# UNITED STATES PATENT AND TRADEMARK OFFICE

| APPLICATION NO.  | FILING DATE | FIRST NAMED INVENTOR | ATTORNEY DOCKET NO.             | CONFIRMATION NO.            |
|--|-------------|----------------------|---------------------------------|-----------------------------|
| 10/527,468   | 12/22/2005  | Oliver Fahnle        | 1248.001                        | 2190                        |

## Office Action Summary

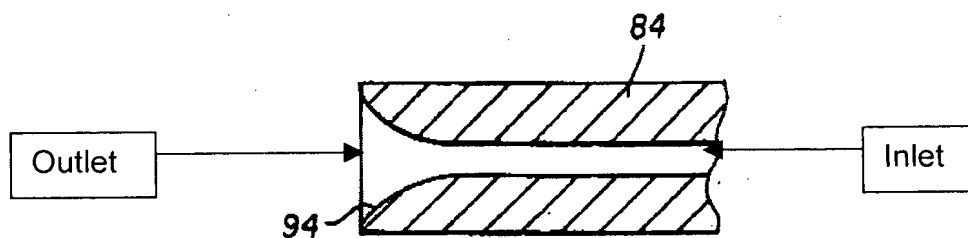
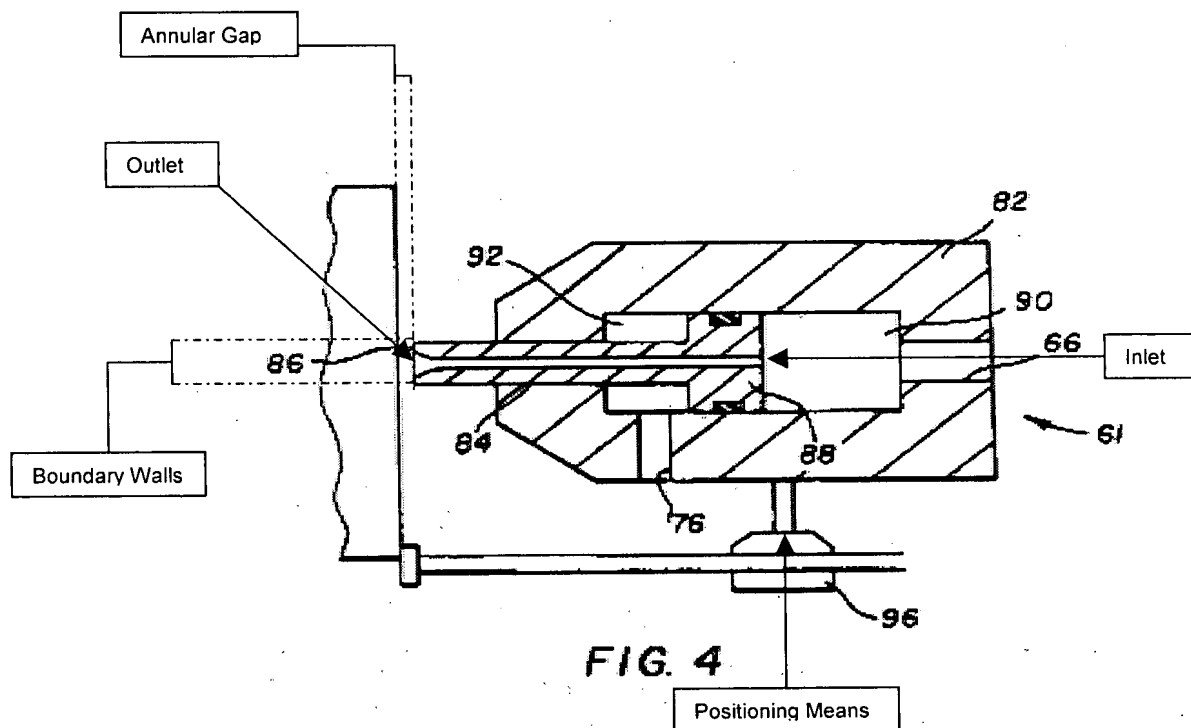
In reference to claims 35-37, 40, 43-46, 49 and 52, Hashish et al. discloses a device for abrasive machining of surfaces of components comprising, a tool having an inlet and an outlet (see figure below) wherein the cross sectional area of the inlet is smaller than the cross sectional area of the outlet, a supply unit (64) for conveying to the inlet a liquid brought under various pressures in which abrasive agents are dissolved and emerged from the outlet, positioning means formed as hydraulic fluid and a control unit (96) both of which are part of the device, the control unit also sets a processing pressure by raising or lowering the nozzle with member (96) and the positioning means guide the tool across a surface to be machined (16) and simultaneously position (Column 4, Lines

55-60) said tool in such a manner that the outlet faces the surface to be machined such that an area of an annular gap (see figure below) defined by boundary walls (see figure below) of the outlet and the surface to be machined is smaller than a cross-sectional area of the inlet, the cross-sectional area of the inlet being greater by a factor of at least 5 than the cross-sectional area of the annular gap, the height of the annular gap being smaller than 3mm and is preferably about 1mm (Column 3, Line 62-Column 4, Line 9), since the height of the annular gap can be varied, one could select a height that provides the cross-sectional area of the inlet being greater by a factor of at least 5 than the cross-sectional area of the annular gap.

In reference to claims 39 and 48, Hashish et al. also discloses that outlet having a circular cross-section, and that the tool has a cylindrical outer contour in the region of the outlet (as seen in the figure below).
